Alpine Street
Garage

11-15 ALPINE STREET
SOMERVILLE, MA

REVISION TO ZBA 2016-75
September 30, 2021

List of Changes; Refer to Accompanying Narrative.

Front Elevation

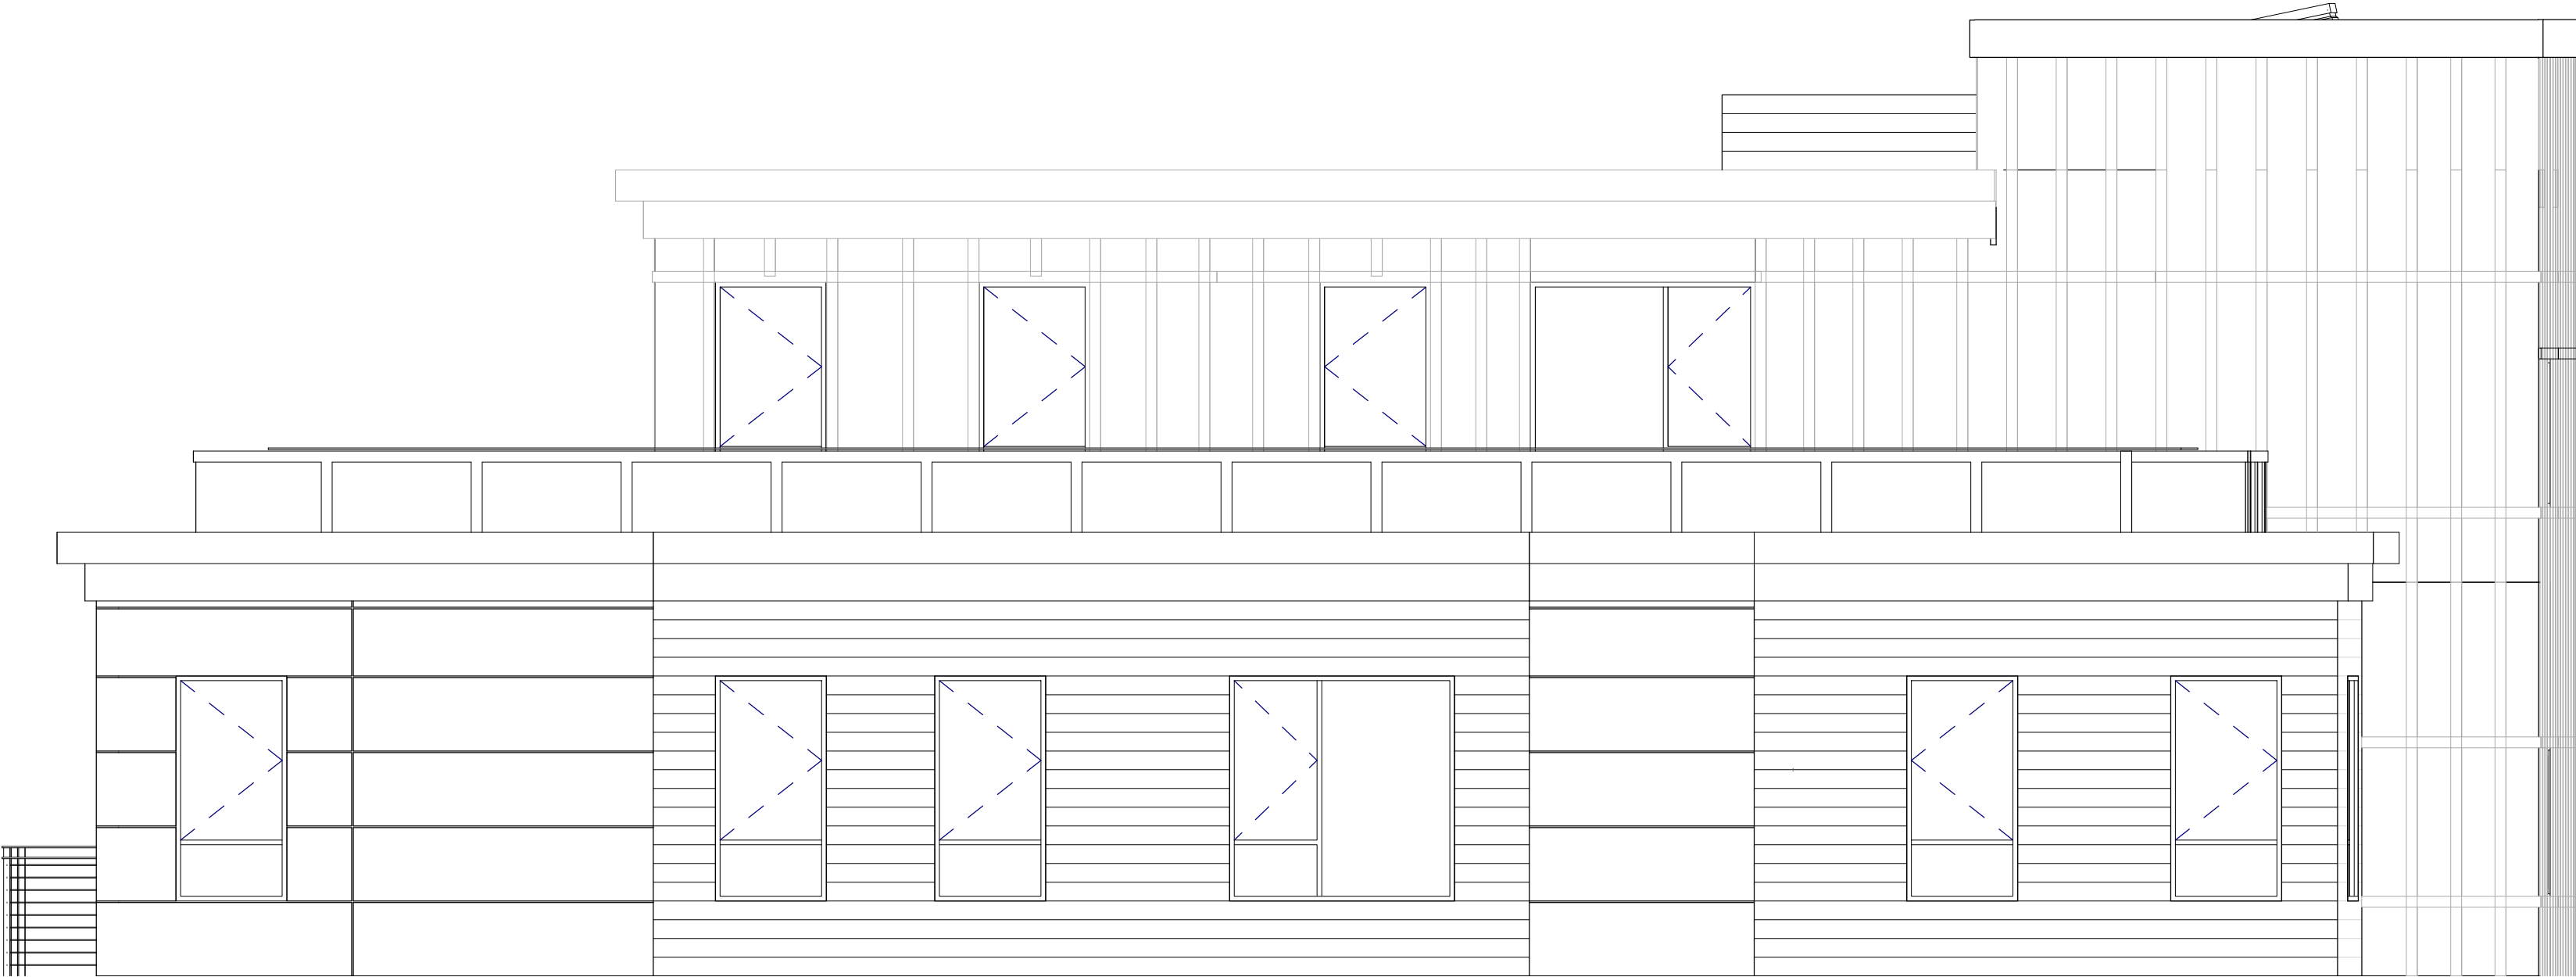
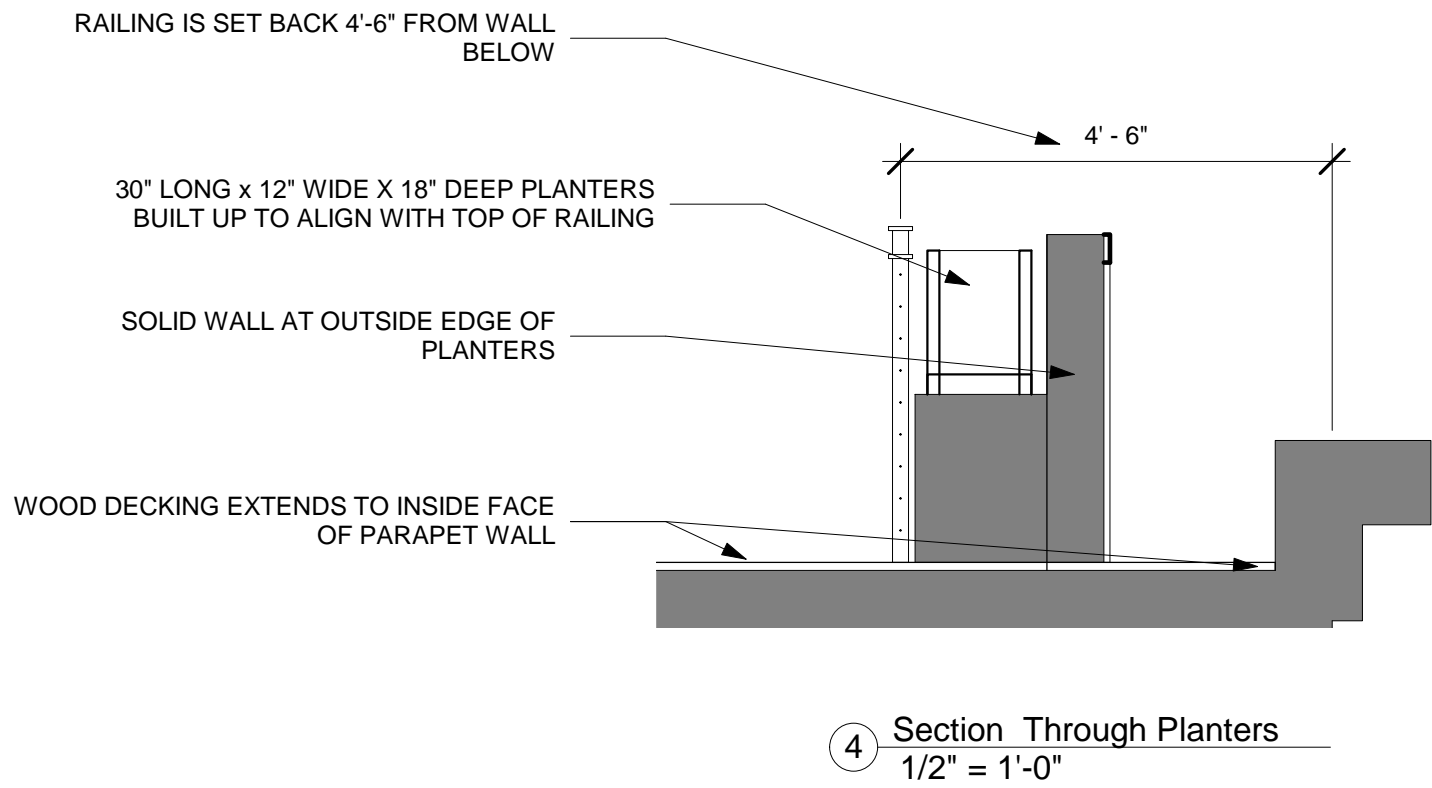
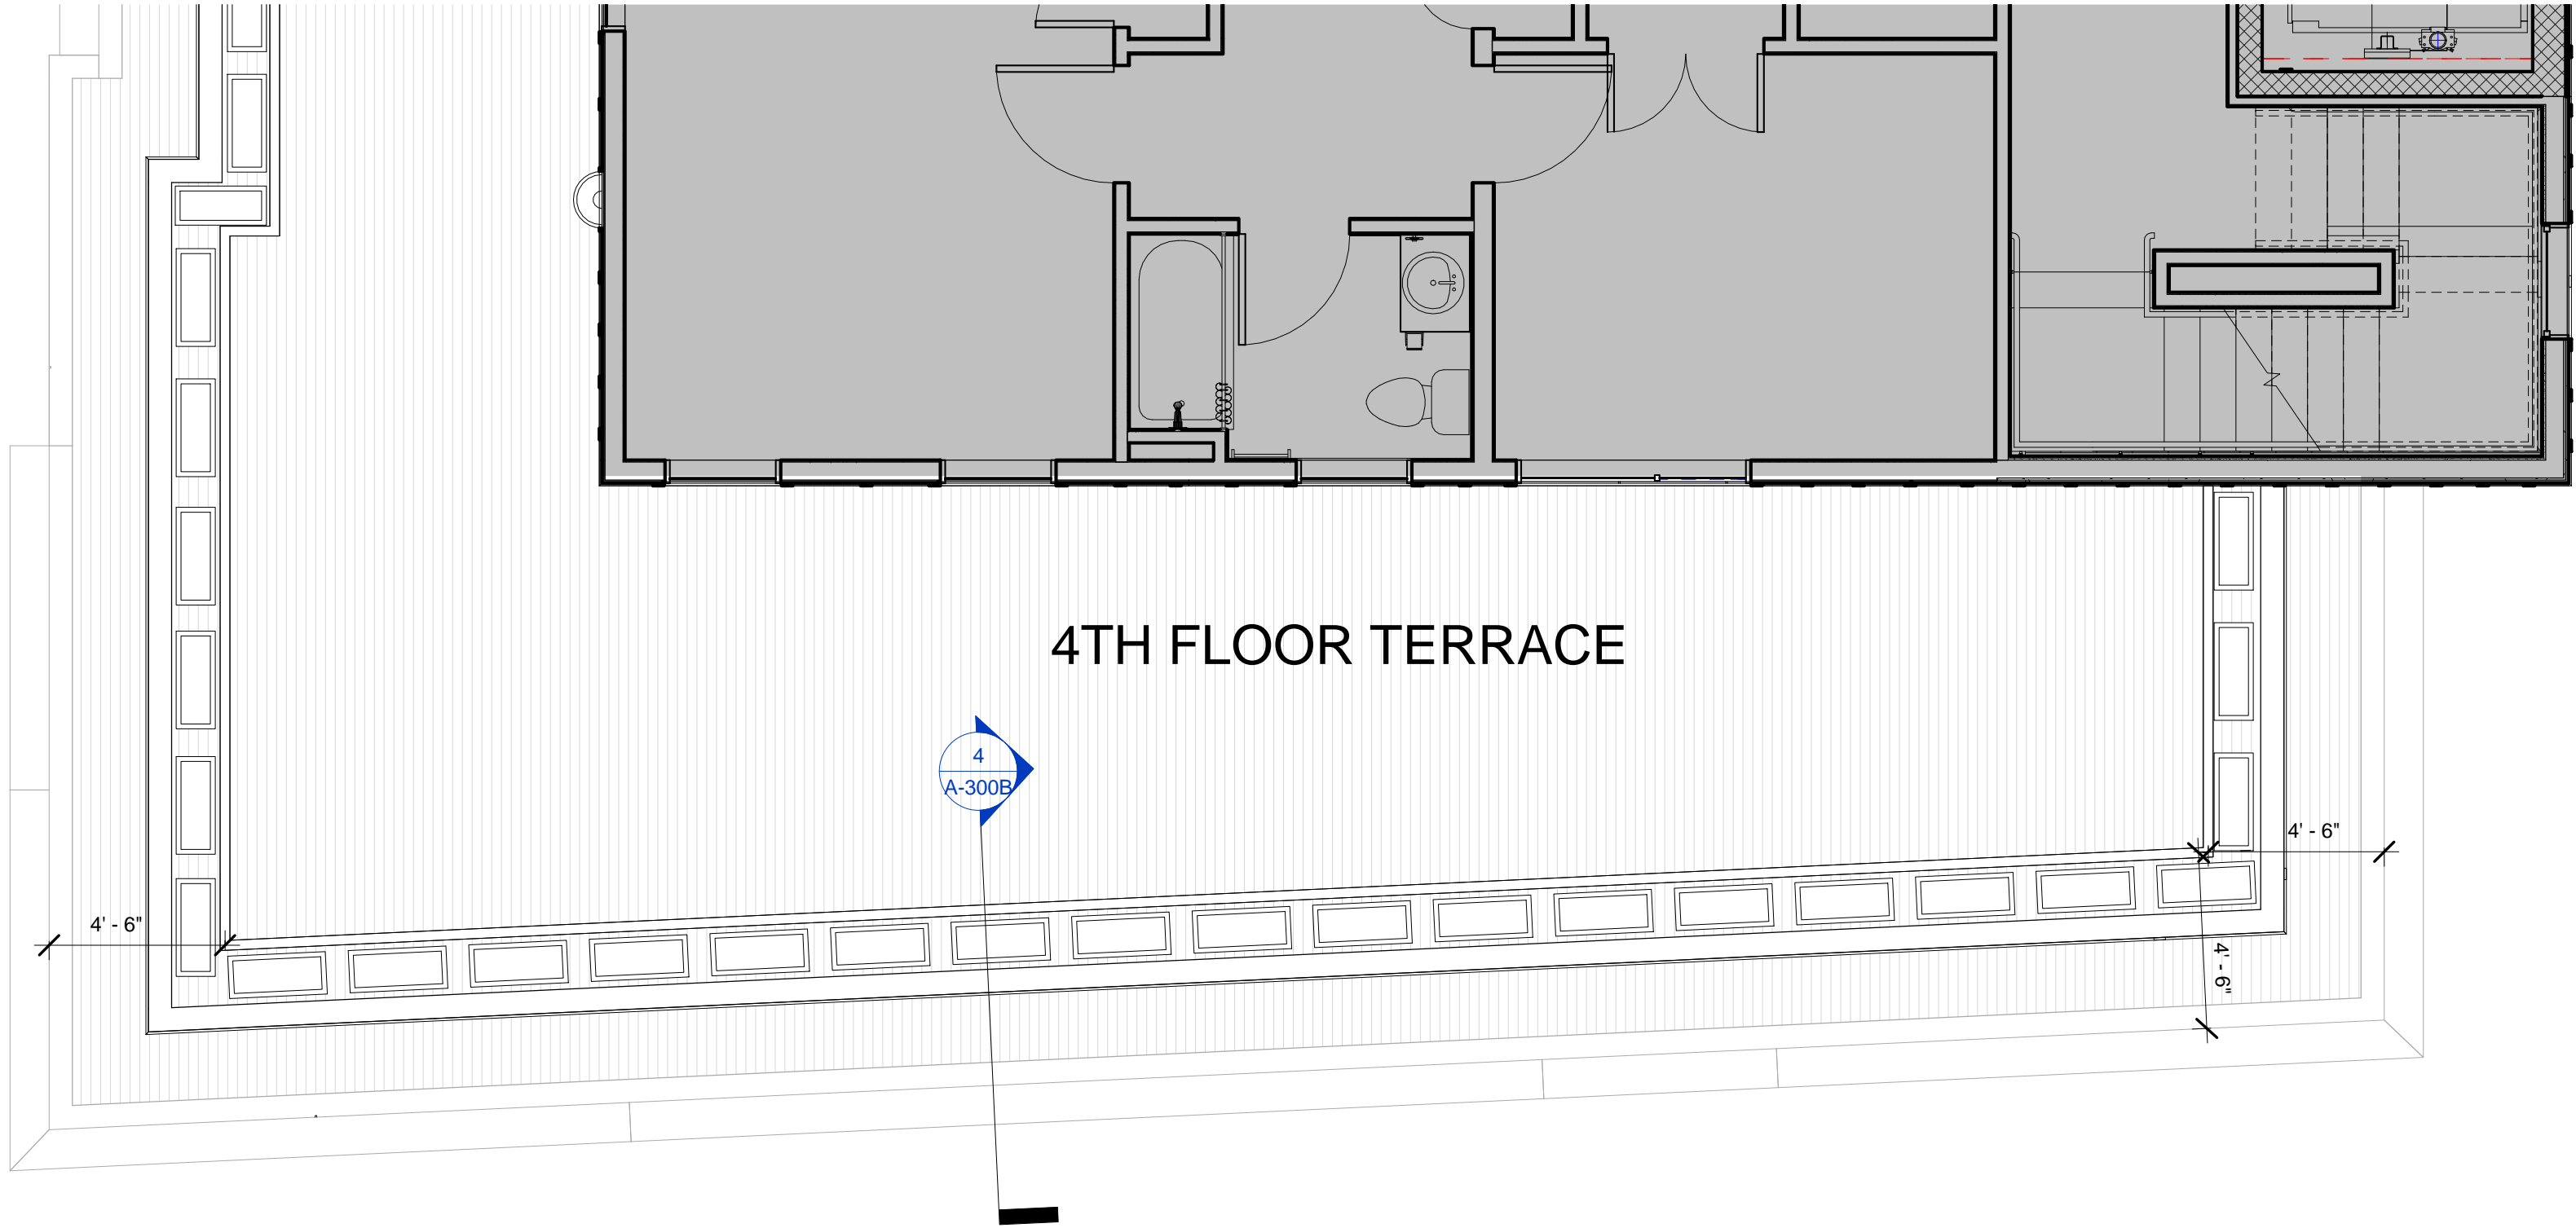
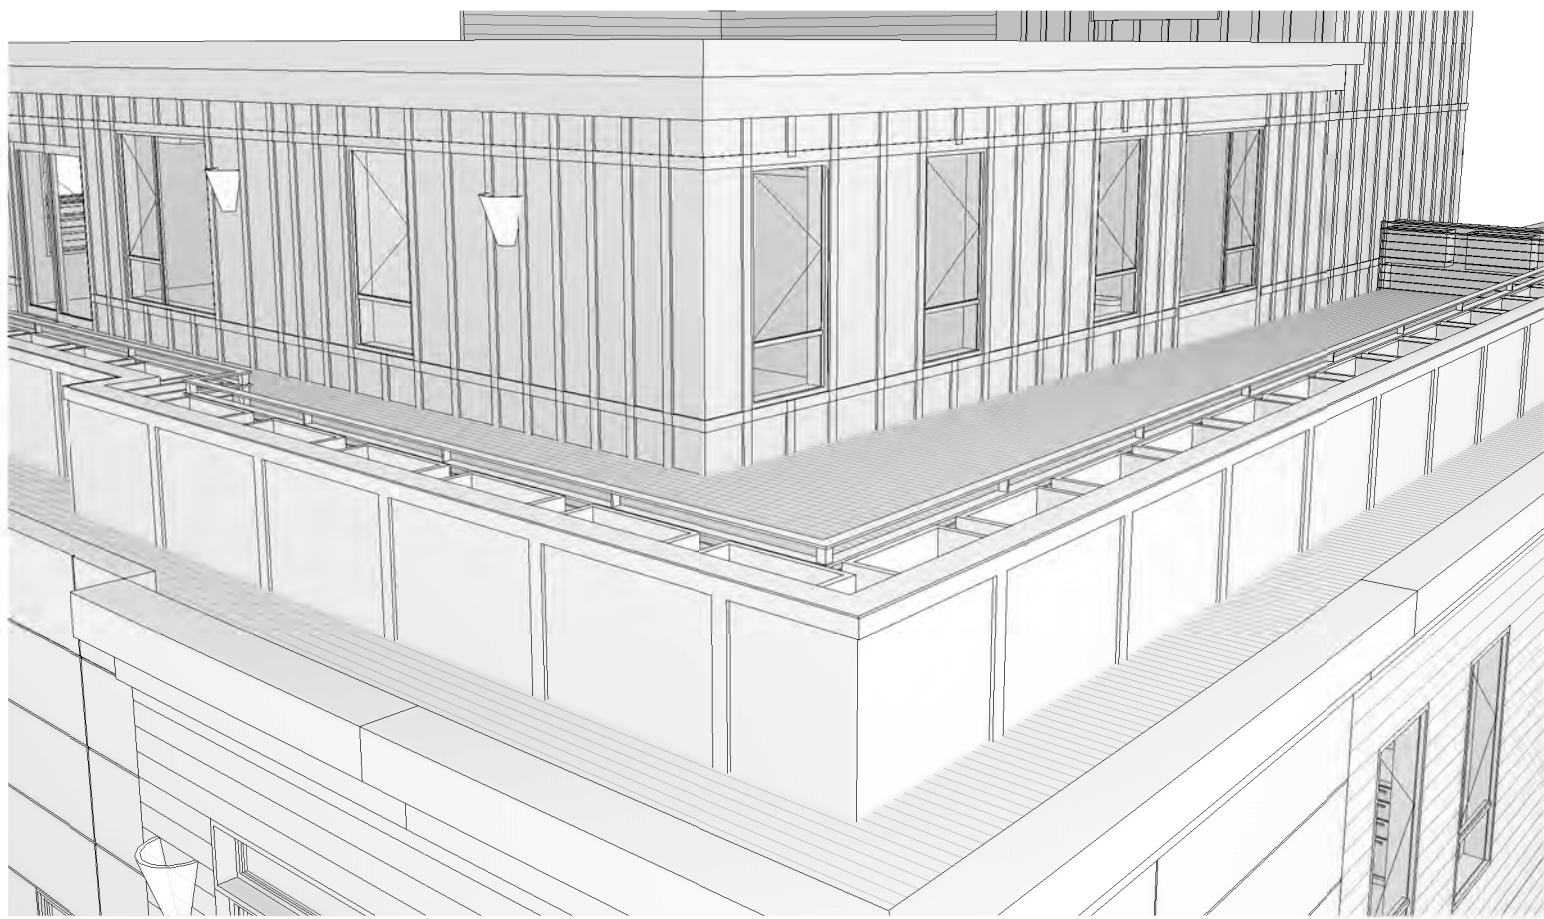
11. The wood decking is being extended to three sides of Unit 401 on the 3rd floor roof (a/k/a the fourth floor deck), thereby creating a larger balcony. The railing is set back 4'-6" from the wall below and planters are being added around the perimeter of the railing.

9. The iron railings are to be horizontal.

3. New cast stone signage at the center of the front façade is now proposed to read "13 Alpine Street".

4. The veneer at the front wall headers and columns is to be changed to cast stone (Arriscraft or Similar).

8. The front wall has been replaced.

12. Cast concrete planters at the front of the building on the ground floor are being proposed.

6. The door and window pattern at the front left side ground floor space has been altered as shown in the elevations.
